GRU DNAPL Team Comments to EPA/Beazer Technology Assessment

USEPA Meeting of December 18-19, 2007

Prepared by Amy Callaway March 10, 2008

TITLE: Elevation Contours for Top of Hawthorn Group Deposits -- Middle Clay Unit

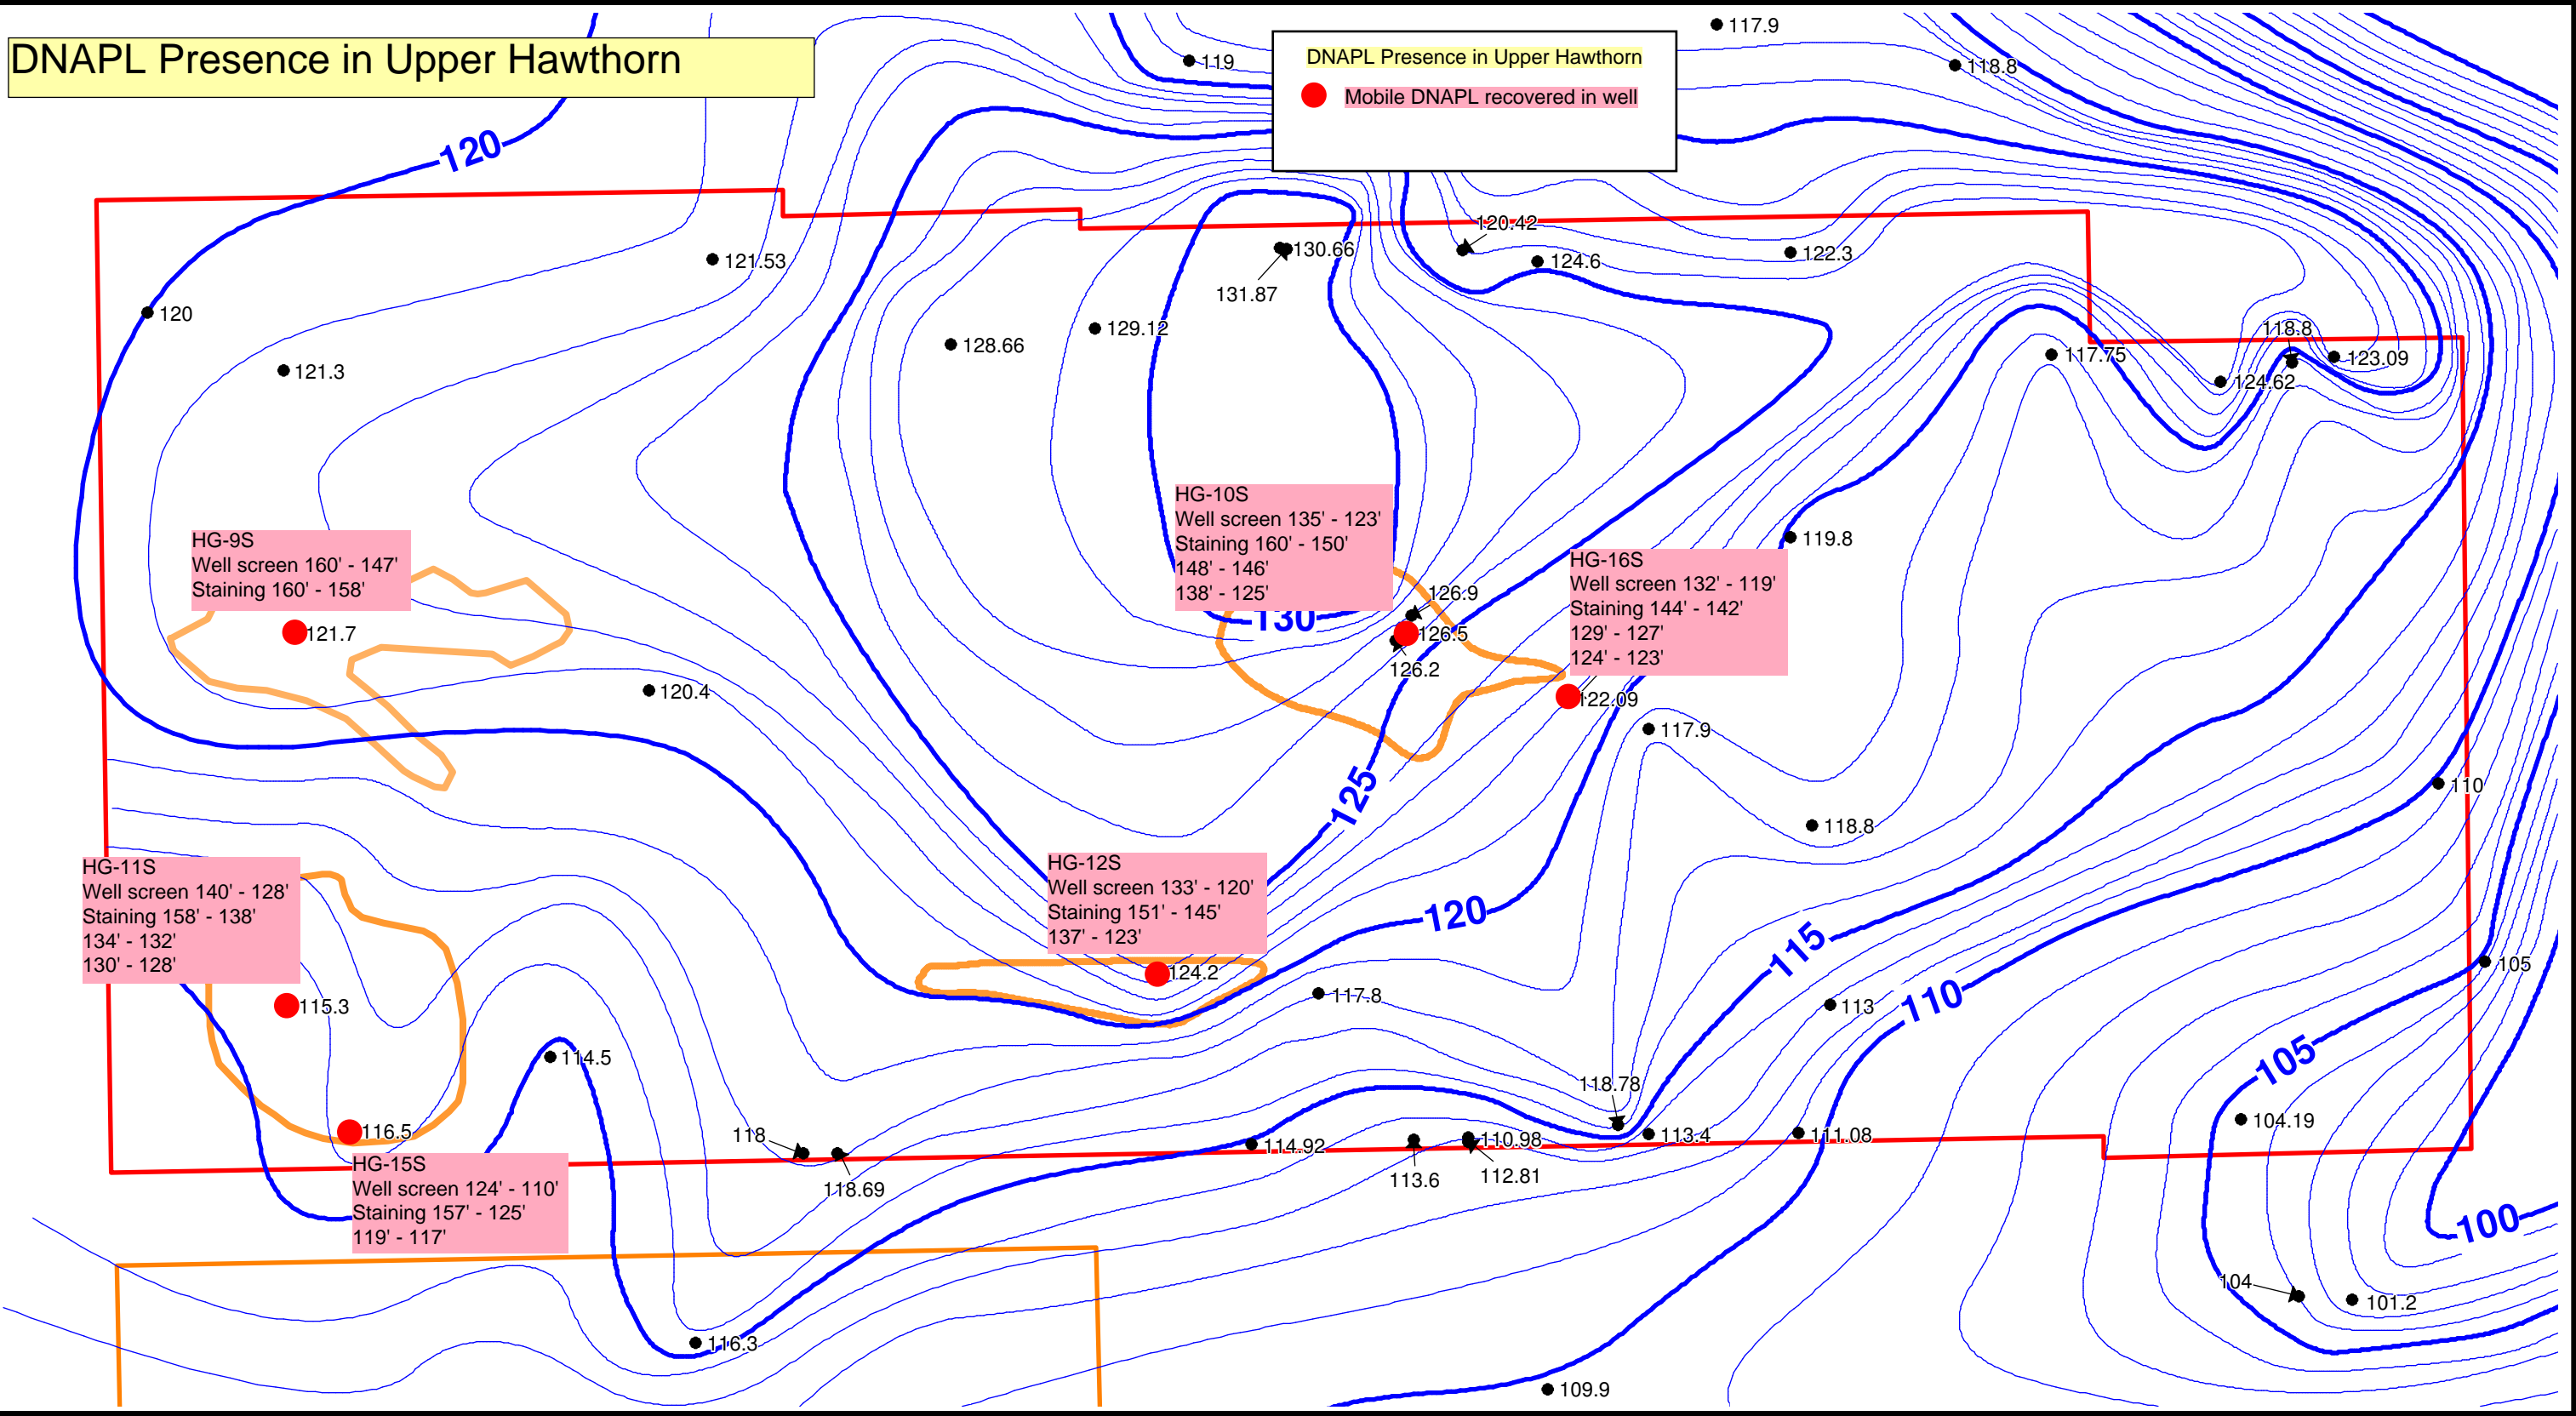
Alternative 4 assumes that in-situ solidification can trap the creosote DNAPL in place. We have modified maps of boring and well locations provided by GeoTrans and provided them as attachments to this document, to show where evidence of DNAPL was observed. EPA and Beazer should clarify where in-situ soil solidification will be implemented. That comment applies to all remedial alternatives for the Surficial and the Hawthorn. Secondly, we strongly suspect that the creosote DNAPL has migrated offsite and to the east of the railroad tracks, therefore certain areas might not be amenable to such treatment. Do EPA and Beazer intend to implement in-situ solidification offsite?

DNAPL Presence in Upper Hawthorn
 ● Mobile DNAPL recovered in well

TITLE: Elevation Contours for Top of Hawthorn Group Deposits -- Lower Clay Unit

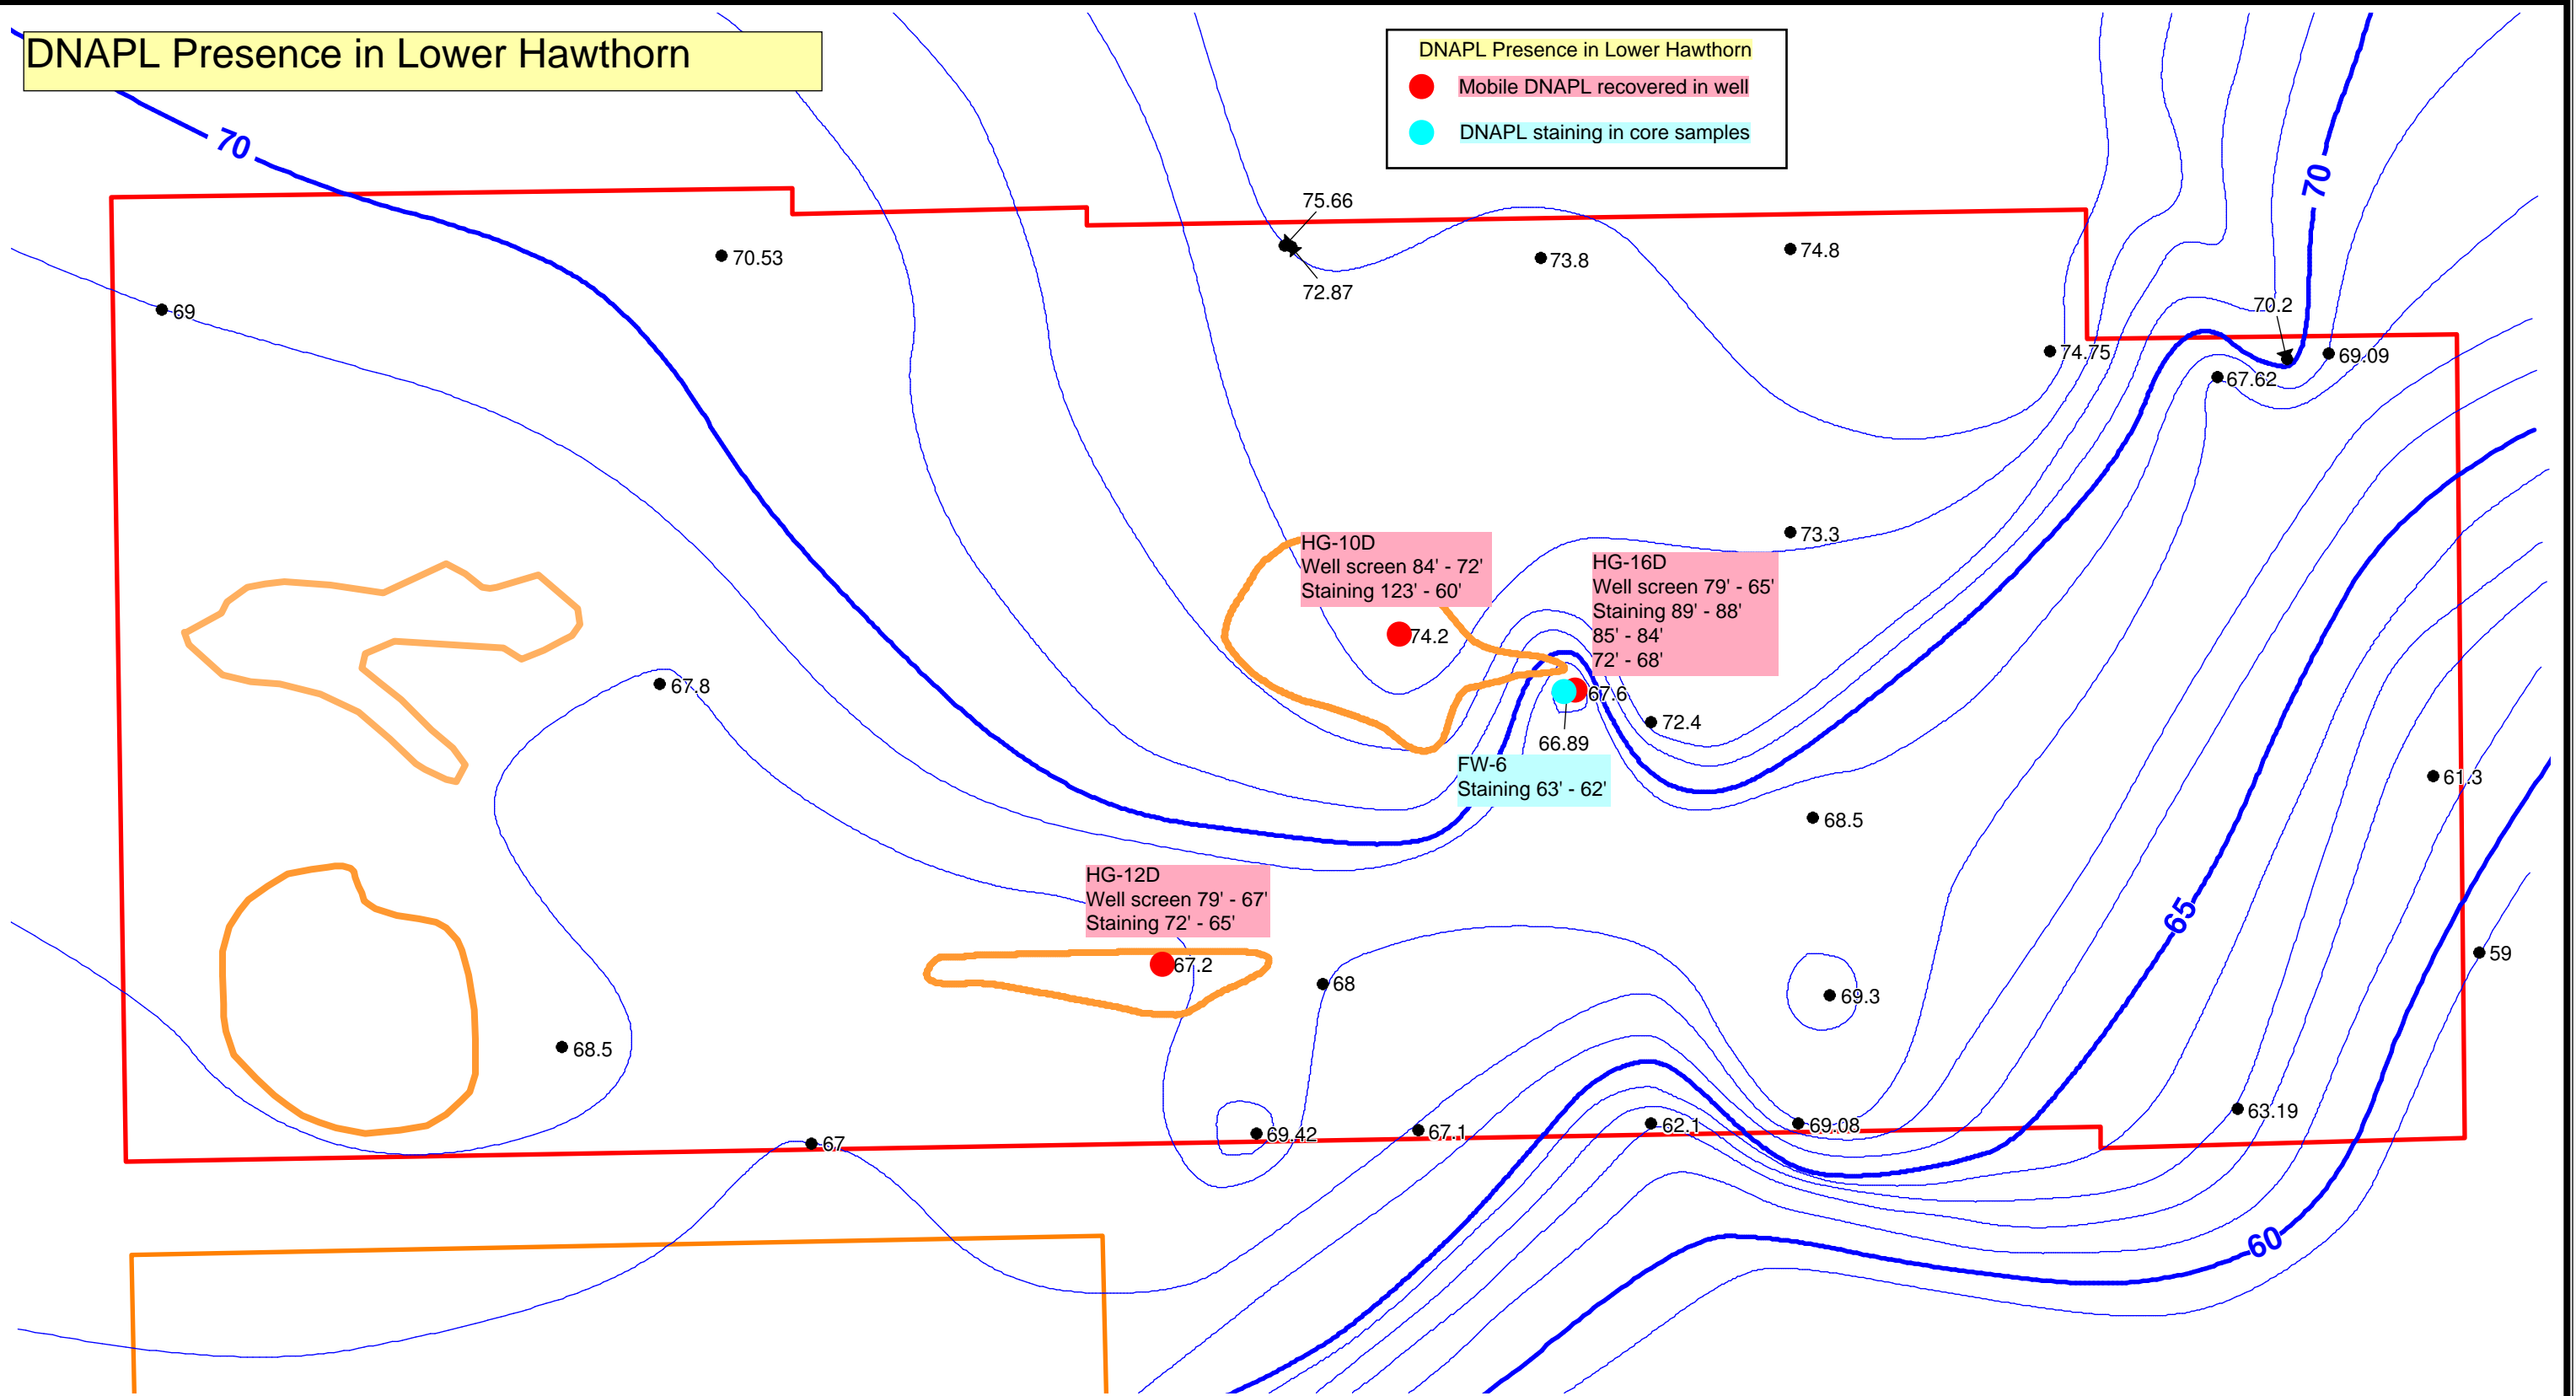
DNAPL Presence in Lower Hawthorn

TITLE: Elevation Contours for Top of Hawthorn Group Deposits -- Upper Clay Unit

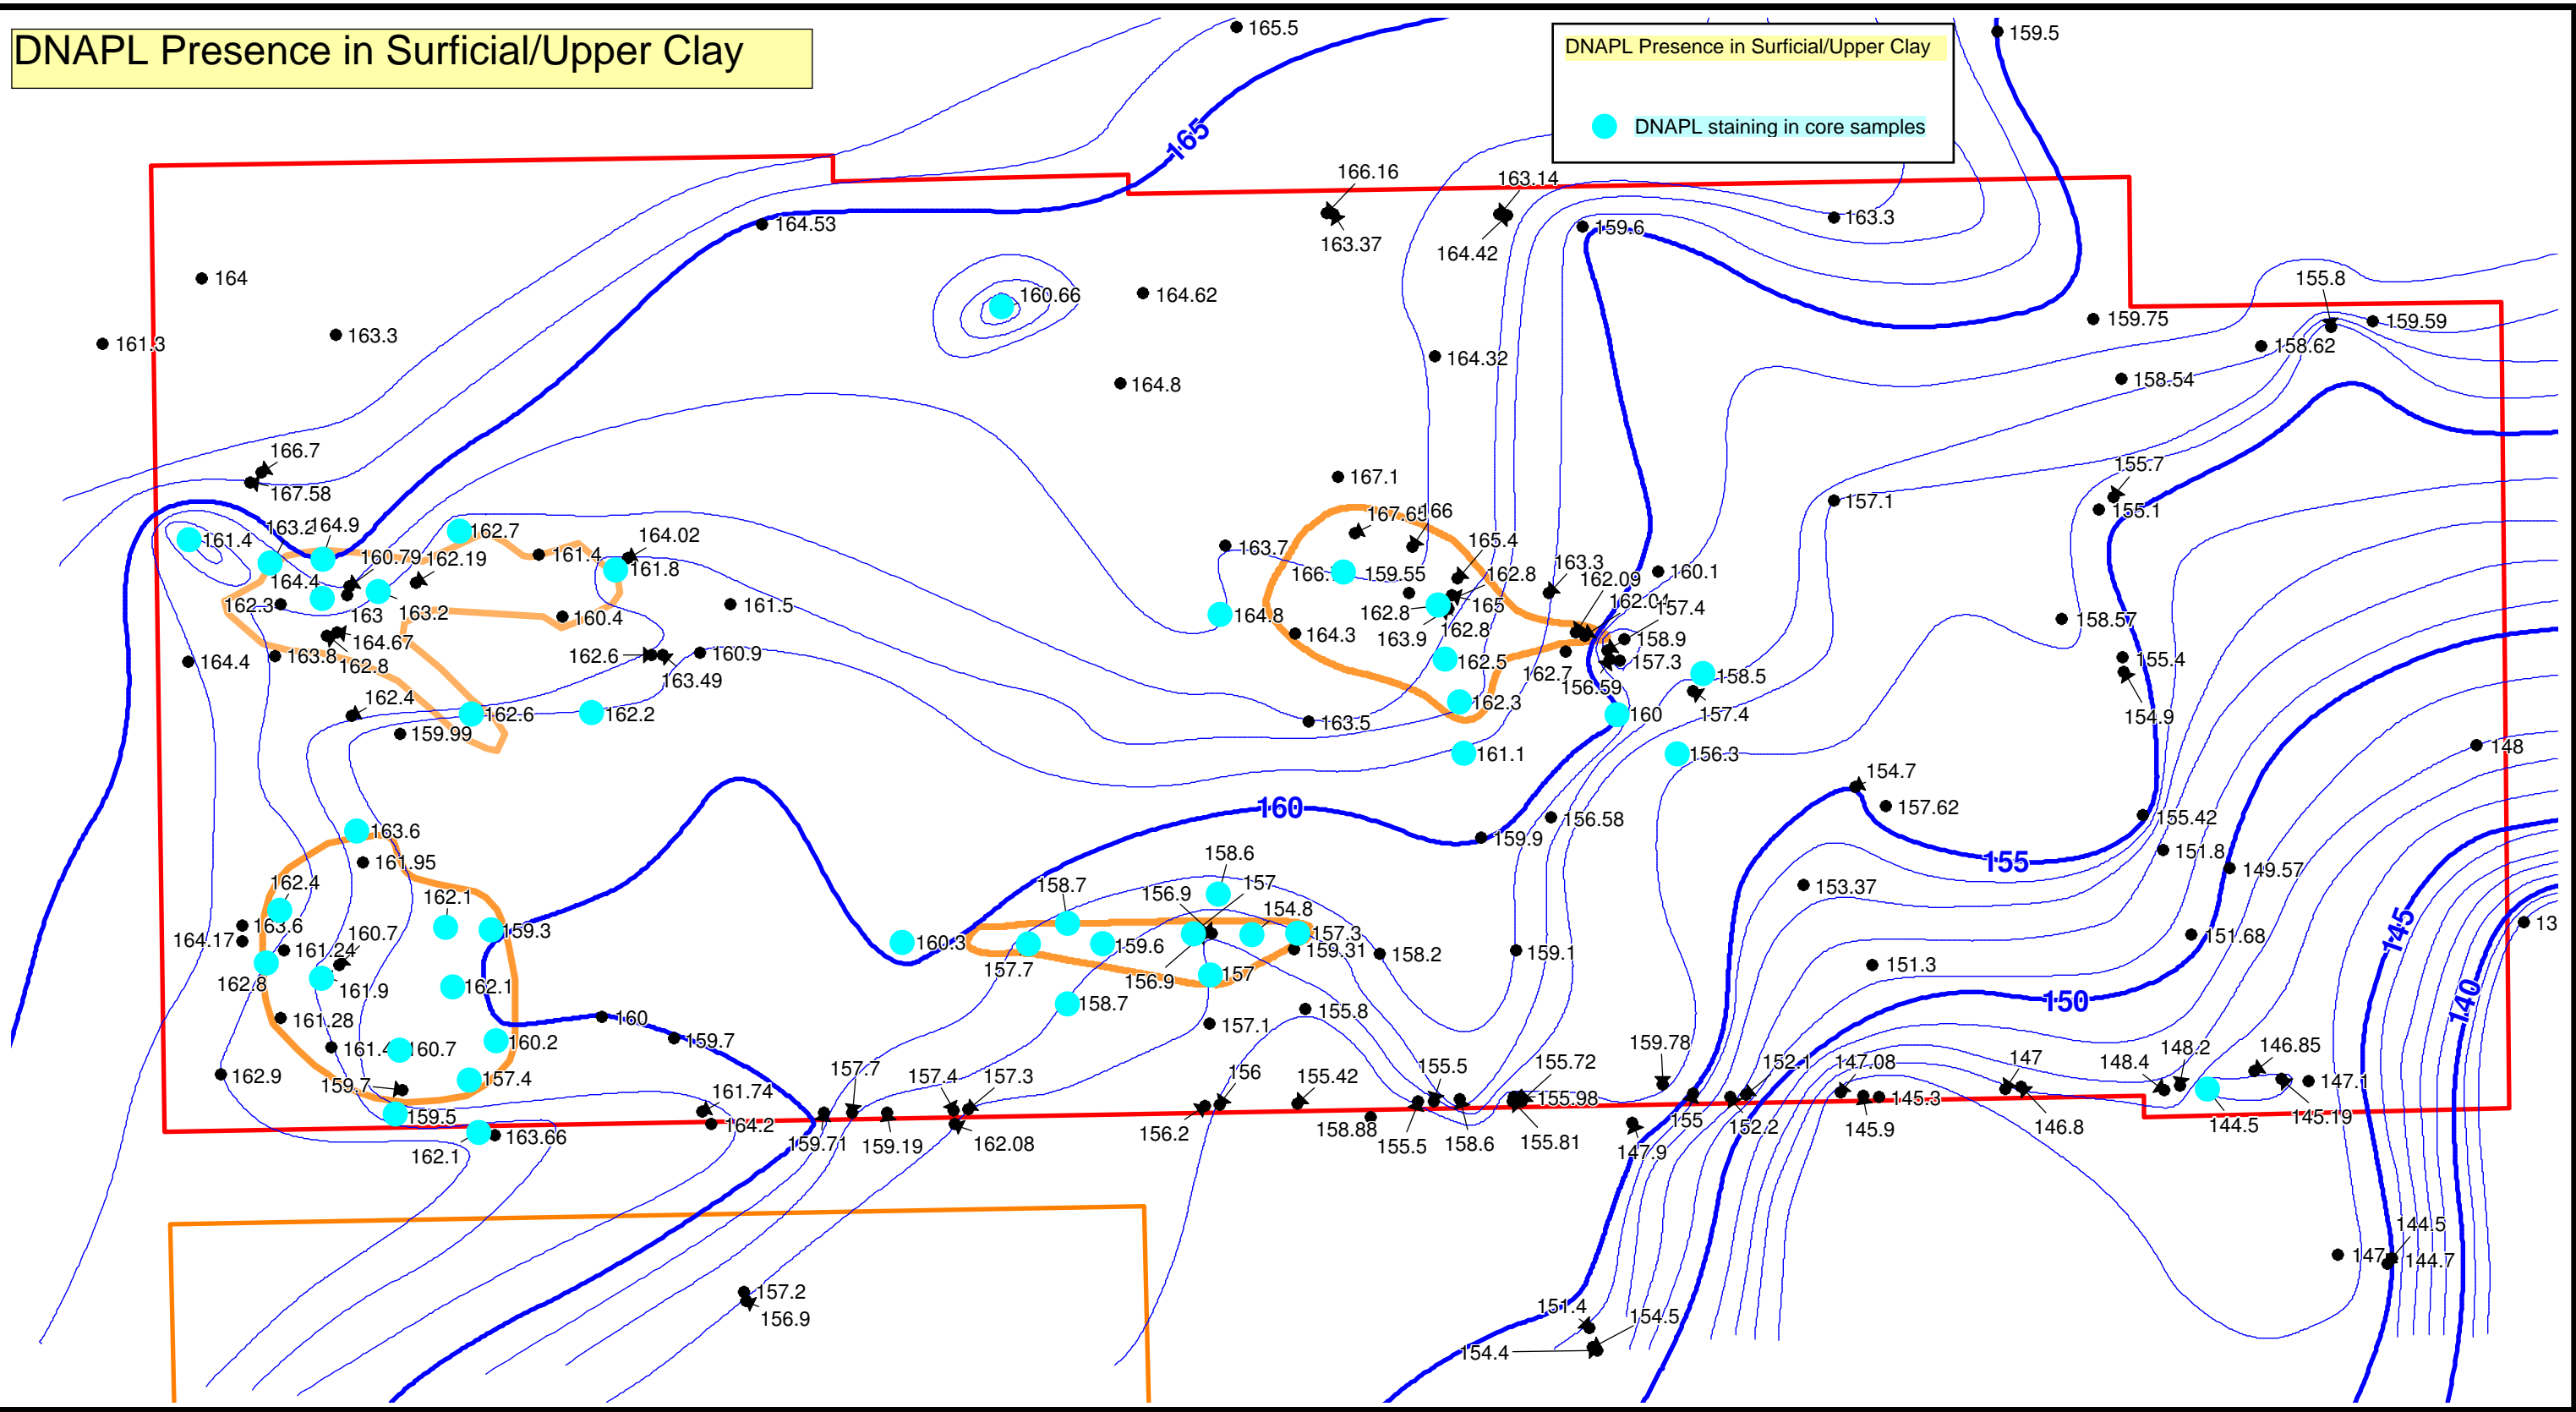
DNAPL Presence in Surficial/Upper Clay
